COUNCIL ASSESSMENT REPORT

Panel Reference	2016SYE095
DA Number	16/150
LGA	Bayside Council
Proposed Development	Integrated Development Application for the construction of a mixed use development incorporating a 4 storey podium with four x 14-storey towers containing residential units, retail space, childcare centre, private recreation facilities, basement and above ground 'sleeved' car parking and 35,532sqm of gross floor area; landscaping and dedication of land along the Church Avenue frontage; construction of southern half of a new east-west street along the northern alignment of the site; landscaping and dedication of a new public park; associated excavation, earthworks and landscaping; and land subdivision.
Street Address	42 Church Avenue, Mascot NSW 2020
Applicant/Owner	Karimbla Constructions Services (NSW) Pty Ltd
Date of DA lodgement	29 August 2016
Number of Submissions	12 objections (Round 1 of notification) 30 (Round 2 of notification) 9 (Round 3 of notification)

List all documents submitted with this report for the Panel's consideration	<ul style="list-style-type: none"> • Annexure A- SEPP 65 and ADG compliance table
Report prepared by	Angela Lazaridis – Senior Developme

Figure 15. Proposed ground floor communal open space

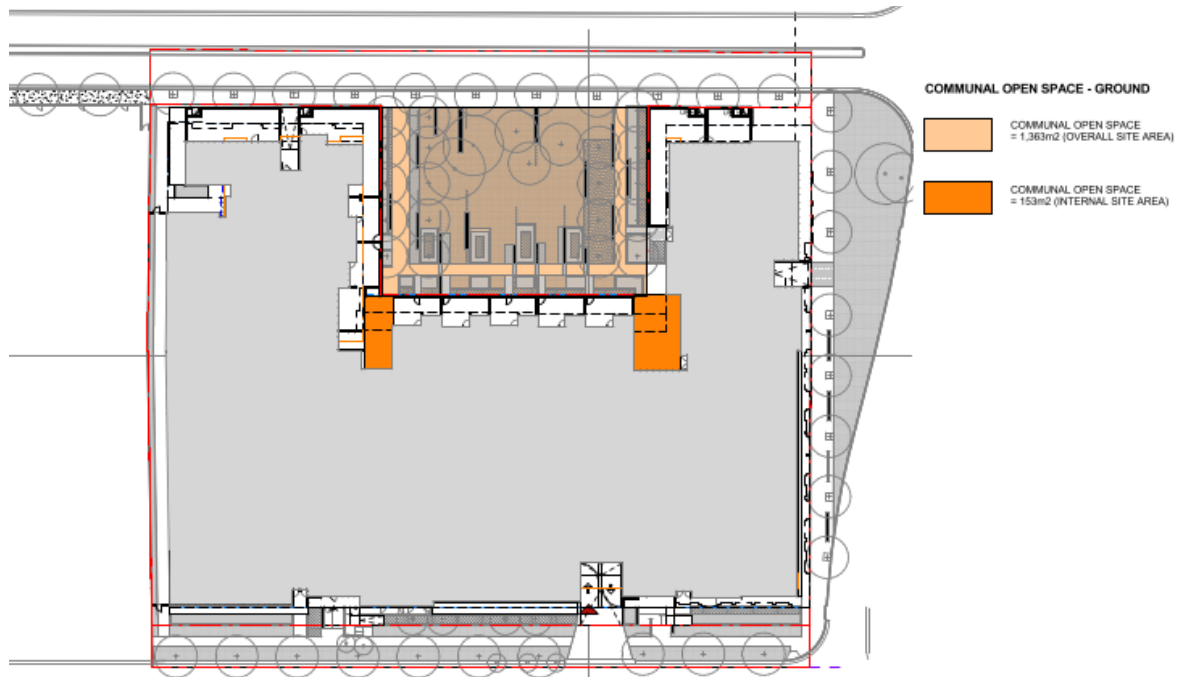
Similar to the discussion above, the applicant has included the public park within the calculation of the communal open space. As demonstrated in the figures below, the total amount of communal open space (including the park) is 2,836sqm (25.5%). Exclusion of the park results in a communal open space area of 1,473sqm (13.3%). The communal open space does not include the gymnasium and the swimming pool.

The communal open spaces proposed on the podium and ground floor contain a variety of uses such as BBQ area, children's play equipment, outdoor fitness gym

Figure 16. Proposed Communal area on the podium

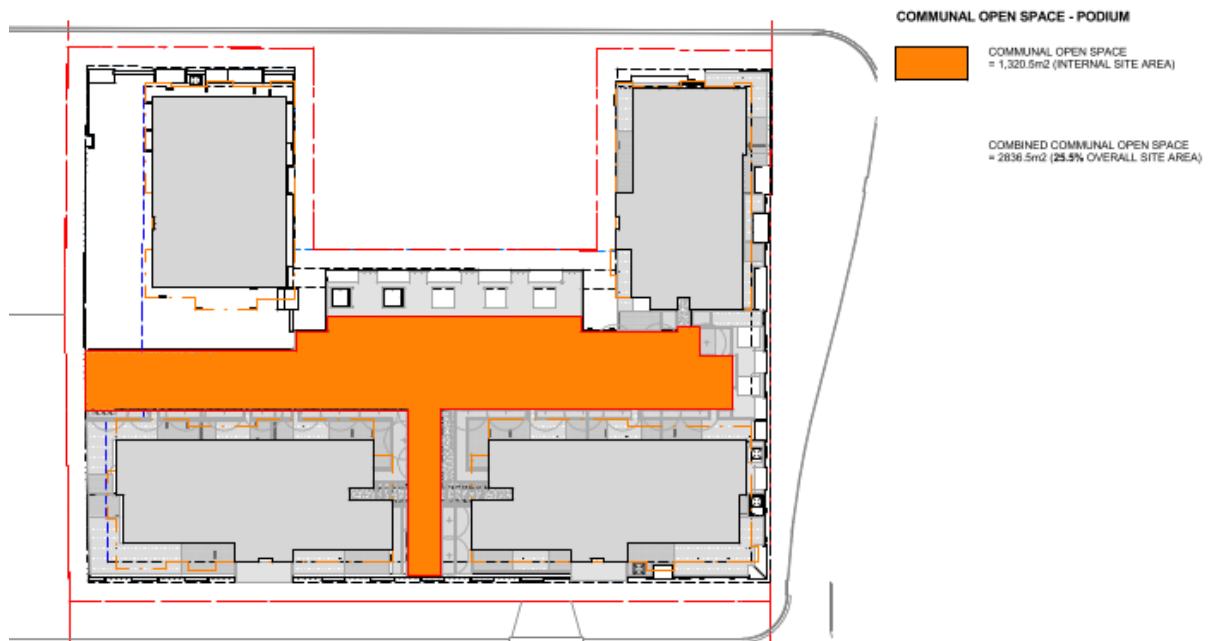
The solar access plans and the perspective shadow diagrams demonstrate that the proposed development will receive sunlight to 242 of the apartments for a minimum of 2 hours in June. This equates to 71% of the proposed apartments and complies with the ADG requirement. Additionally, only 43 of the 340 apartments have no direct sunlight which results in a total of 13% thereby complying with the maximum number of apartments with no direct sunlight of 15%. The communal open space on the podium receives the minimum solar requirement between 10am to 1pm in mid-winter to 50% of the principal communal area.

Figure 20. Proposed and existing overshadowing onto 8 Bourke Street mid-winter between 9am to 12pm

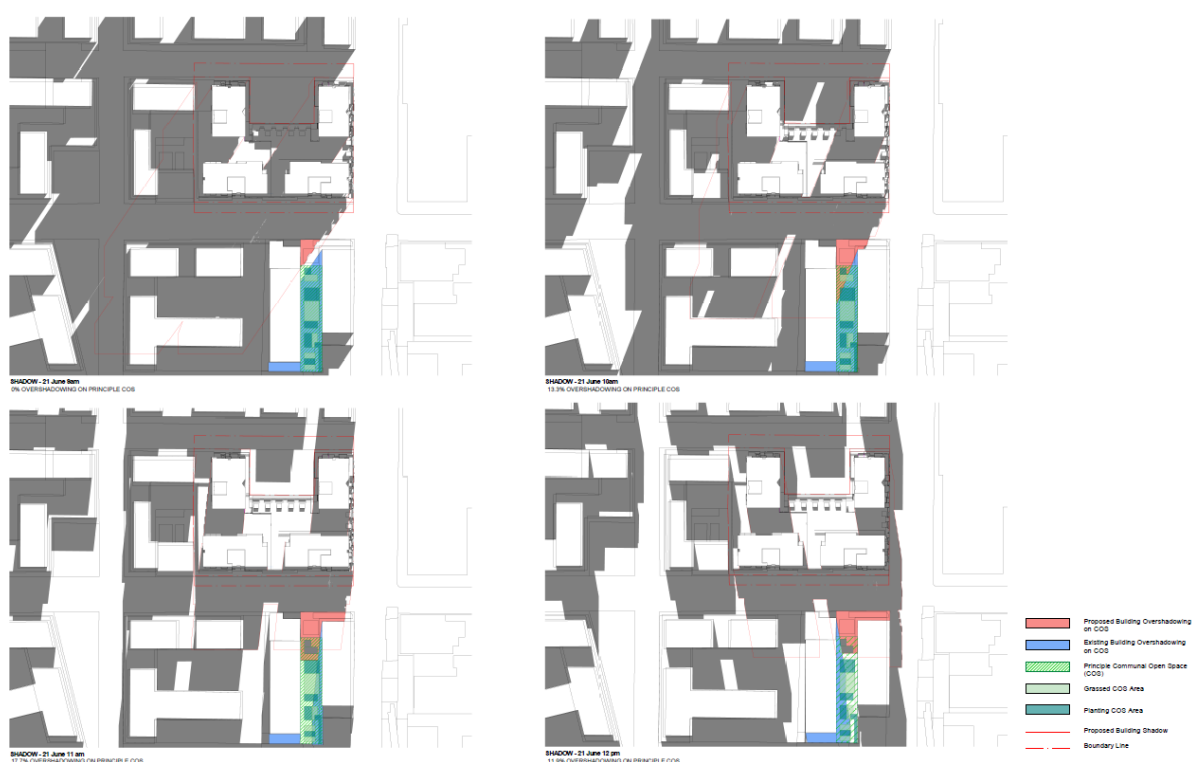
Further to the table above, the below shadow diagrams demonstrate the degree of overshadowing to the principal communal area at 8 Bourke, both existing and proposed for mid-winter.

Comment: As discussed earlier in the note, the proposed development will overshadow the northern side of the communal podium area of 8 Bourke Street between 9am to 3pm in mid-winter. The shadow diagrams that accompanied the development application demonstrated that the neighbouring communal open space will receive the minimum 2 hours of sunlight to the principle usable area of the space at 10.30am to 12.30pm. The remaining open space will be overshadowed by the existing buildings at 8 Bourke Street. There was no existing overshadowing onto the neighbouring property due to 42 Church Avenue having a two storey built form and its location on the corner of Bourke Street which is the main thoroughfare within Mascot Station. Council is satisfied that the additional overshadowing cast by the subject site would not remove the significant amount of sunlight to the property to the south. Additionally, the applicant has provided shadow diagrams for March/September (equinox) which demonstrates that the proposed development will not impact the southern site.

Figure 22. Example of a typical floor demonstrating building depth and amenity

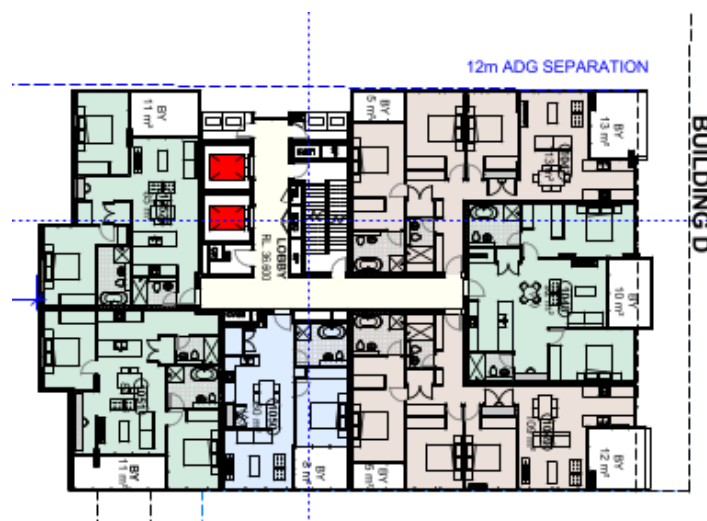
The building depth in each tower above the podium does not comply with the 12-18 metre depth provision however the depth of the buildings continue to allow sufficient cross ventilation and solar amenity to the apartments, due to their orientation with the buildings. Below is a typical floor layout in Building D which demonstrates that the apartments receive adequate amenity. The facades are articulated with protruding balconies which contribute to the building depths. The non-compliances are supported.

Figure 23. Typical floor layout showing the building separation non-compliance and location of surrounding streets

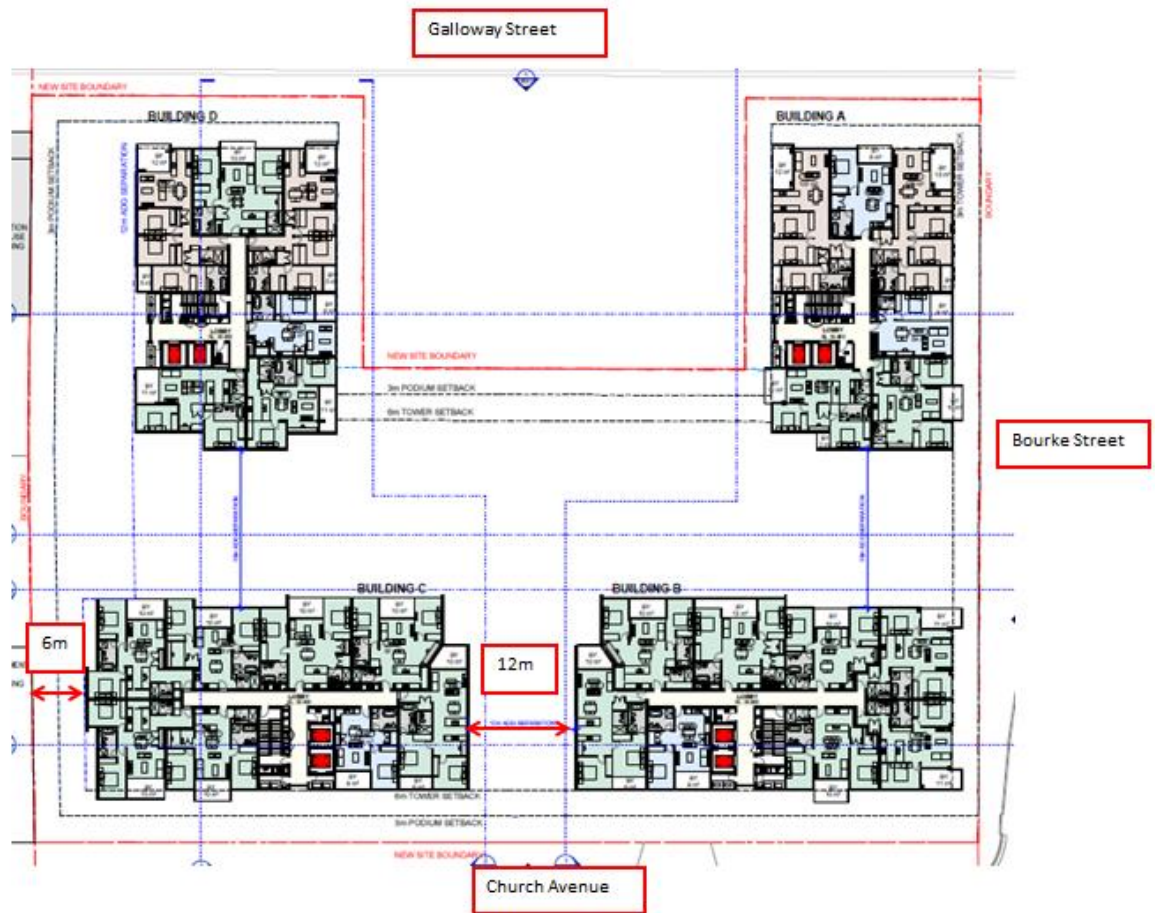
While the building separation proposed is not consistent with the ADG control, the site fronts onto three streets (Bourke Street, Church Avenue and Galloway Street). The separation between the site boundary and the surrounding sites to the north, south and the east is approximately 25-30 metres (width of the street) and greater. Considering that there is no development proposed directly adjacent to the north, south and east of the site, the non-compliance to these elevations is acceptable.

The figure above demonstrates a typical floor plan for the development. The figure is of Level 8 and demonstrates the location of the site centred between three streets. However, the plan demonstrates that the western side of Building C proposes a 6 metre setback from the western boundary line. This setback extends from the podium level to Level 13. Therefore, this elevation does not comply with the 9 metre and 12 metre building separation from the site boundary as required in the ADG. The development immediately to the west of the site contains a five storey commercial building. There are a number of windows on each level of its eastern elevation. As there is a non-compliance in the separation, the applicant has proposed highlight windows within the proposed bedrooms in the development to prevent any overlooking into the commercial building. While the building separation is not ideal, the commercial building is located within 1 metre of the boundary between the two sites. It is considered that the neighbouring development will continue to receive solar amenity to the building.

Figure 24. Plan highlighting the balconies protruding over the setback zone

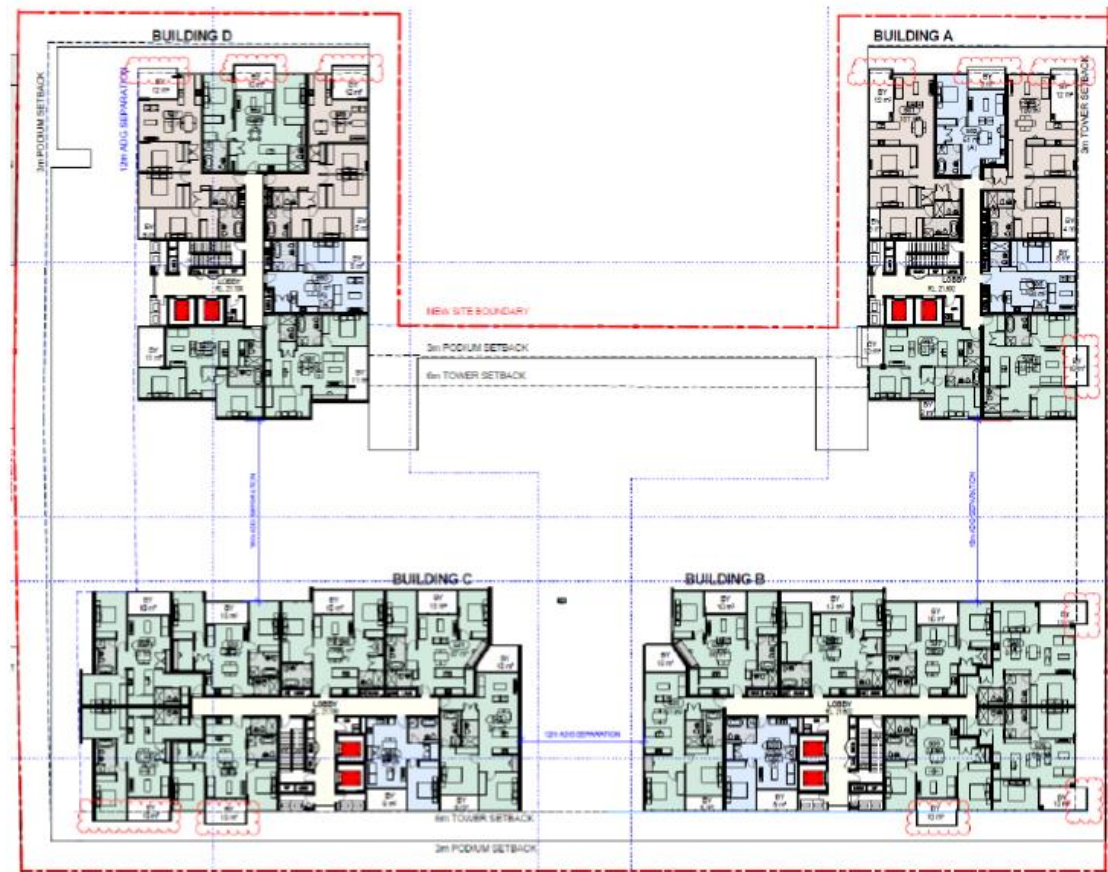
‘The diagram below shows (clouded) the extent of balcony encroachments into the 3-metre setback zones along the north, east and south of the site. The diagram shows that only a very minor proportion of the frontage of each building is occupied by balcony encroachments. The projections for the north facing balconies are subtle; and the projections along the east and south sides of the development are slightly more generous but only occupy a very small proportion of the elevations. The photomontages that are submitted with the application show that the articulation created by these minor projections into the setback zones will have a very positive contribution to the architecture of the buildings. Without these minor projections, the buildings will appear flat and uninteresting. The minor projections do not give the impression that the buildings are eroding the overall setbacks of the buildings, as the vast majority of the elevations are set back in compliance with the required setbacks. For these reasons, it is considered beneficial to allow the minor encroachments and the minimal variation sought from full DCP compliance.’

Considering the applicant's justification and the degree of articulation that is provided by the protruding balconies and the apartment on the south western corner of Building C, the non-compliance is acceptable.
